**CALIFORNIA COASTAL COMMISSION**

**COASTAL DEVELOPMENT PERMIT APPLICATION**

**Application number** .....3-05-031, Bubba Gump's Deck Expansion

**Project location**.....720 Cannery Row, Monterey (Monterey County)

EXHIBIT NO. 2
APPLICATION NO.
3-05-031
Pg 1 of 3

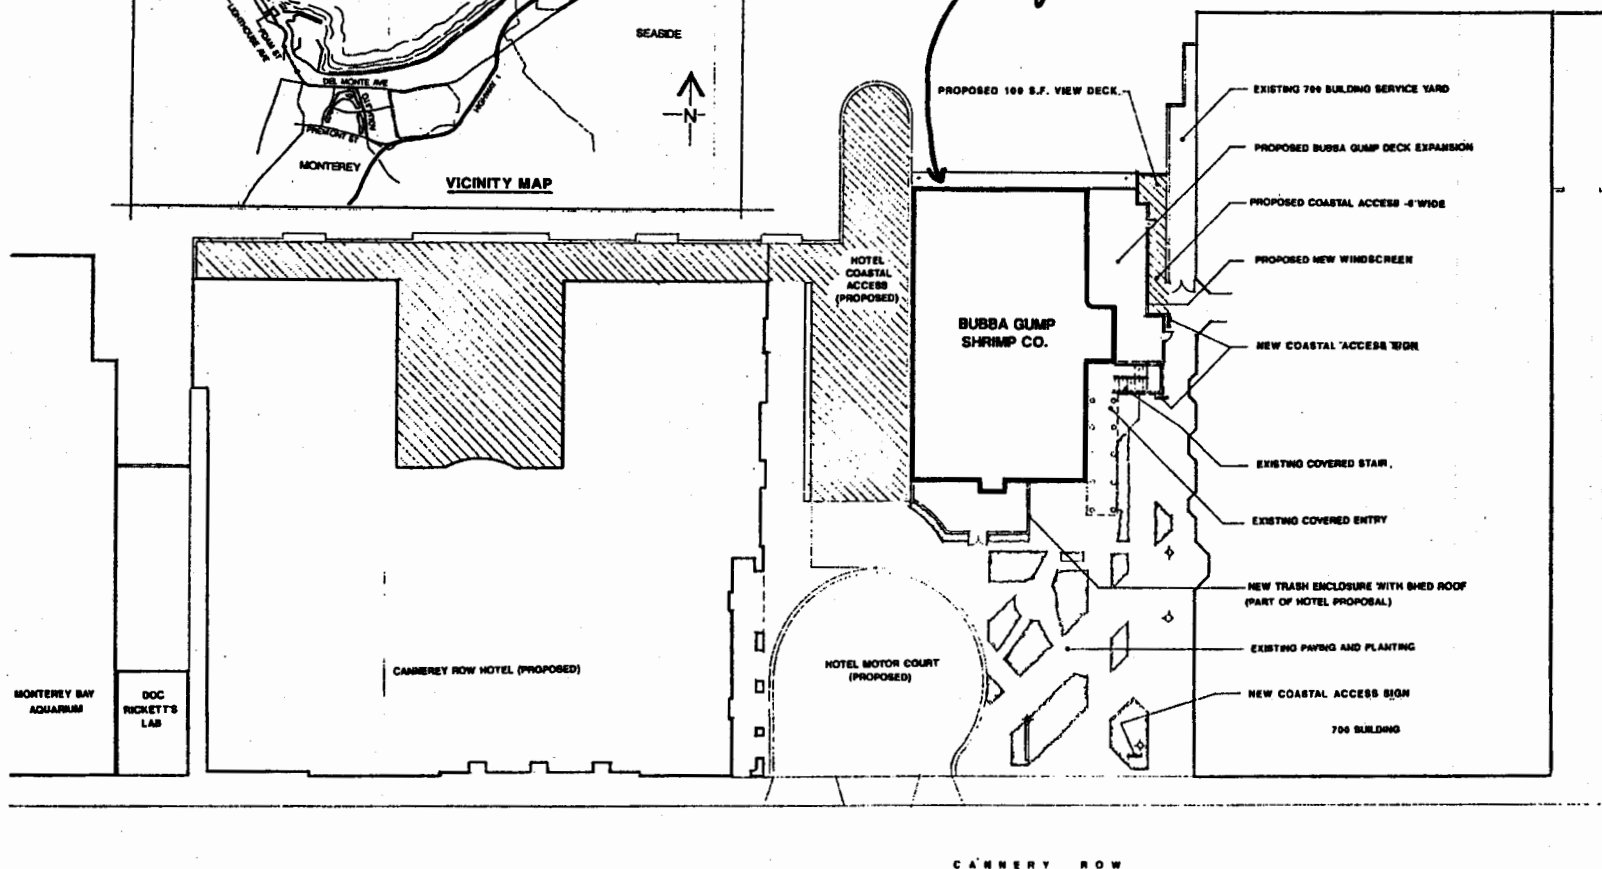
Coastal Act Section 30210 requires maximization of public access. Cannery Row LUP Public Access Policy 3(d)(2) provides for maximization of public access by requiring a minimum lateral access of 8 feet in width across the seaward side of structures, as a condition for *all* new development. This policy further provides that continuous lateral access, linking adjacent parcels along Cannery Row, be required for areas shown in Figure 4a of the Cannery Row LUP (see Exhibit 3 for Figure 4a). The subject parcel is one of the areas shown in Figure 4a. As discussed above, the approved Monterey Peninsula Hotel has extensive public access amenities, including lateral access along the entire hotel seaside frontage, which extends to a large promenade area directly adjacent to the Bubba Gump Shrimp Company. The proposed project includes extension of an existing approximately 6-foot-wide window-washing ledge that runs laterally along the restaurant's ocean frontage (this extension is necessary to provide cleaning access for the proposed windscreen). Overall, the project proposes 1,560 square feet of new development over public tidelands, of which 23% is for general public access. The proposed project does not provide for lateral public access along the ocean frontage of the Bubba Gump Shrimp

Company, inconsistent with the guidance provided by Cannery Row LUP Public Access Policy 3(d)(2). Thus, the proposed project provides more than three times as much private restaurant space over public tidelands as it does general public access space (1,200 square feet versus 360 square feet). This ratio of private to public use is inconsistent with Coastal Act Section 30210, which requires maximization of public access. Furthermore, 360 square feet of general public access is not sufficient to mitigate for the impact of 1,200 square feet of private development over public tidelands. To mitigate for this private use of public land, additional public access is required. Thus, Special Condition #1 requires the installation of a minimum 8-foot-wide lateral accessway along the ocean frontage of the restaurant. This accessway will provide a lateral connection with the approved Monterey Peninsula Hotel access when that access is developed. This lateral accessway will provide approximately 720 square feet of additional public access to the project, for a total of approximately 1,080 square feet of new public access. The access will be required to be open from 8:00 a.m. to one hour after sunset, consistent with the lateral access approved for the Monterey Peninsula Hotel. As conditioned, the project is consistent with Coastal Act Section 30210 and Cannery Row LUP Public Access Policy 3(d)(2).

required 8-ft lateral access (Sp. Cond. #1)

1. **Public Access. PRIOR TO ISSUANCE OF THE COASTAL DEVELOPMENT PERMIT,** the applicant shall submit revised plans that include a cantilevered public accessway along the lateral seaside frontage of the restaurant. This lateral access shall be a minimum of 8 feet in width. The lateral access shall provide for a connection between the 100 square foot view deck and the approved Monterey Peninsula Hotel public access (when constructed), as shown in Exhibit 2. The lateral public access, the new vertical public access, and the view deck area shall be open daily (whether or not the outside dining deck is in active use) from 8:00 a.m. until one hour after sunset. The lateral access may be closed during these hours during storms or otherwise dangerous conditions, but must be reopened as soon as the dangerous conditions have passed. The permittee is responsible for the maintenance of the lateral access. The revised plans shall also include coastal access signs placed at both ends of the lateral access. The lateral access shall be constructed and ready for use prior to occupancy of the dining deck addition. If lateral access is required at the adjacent 700 Cannery Row building in the future, the permittee shall cooperate in connecting the existing lateral access at the Bubba Gump Shrimp Company site to the lateral access at the 700 Cannery Row building.
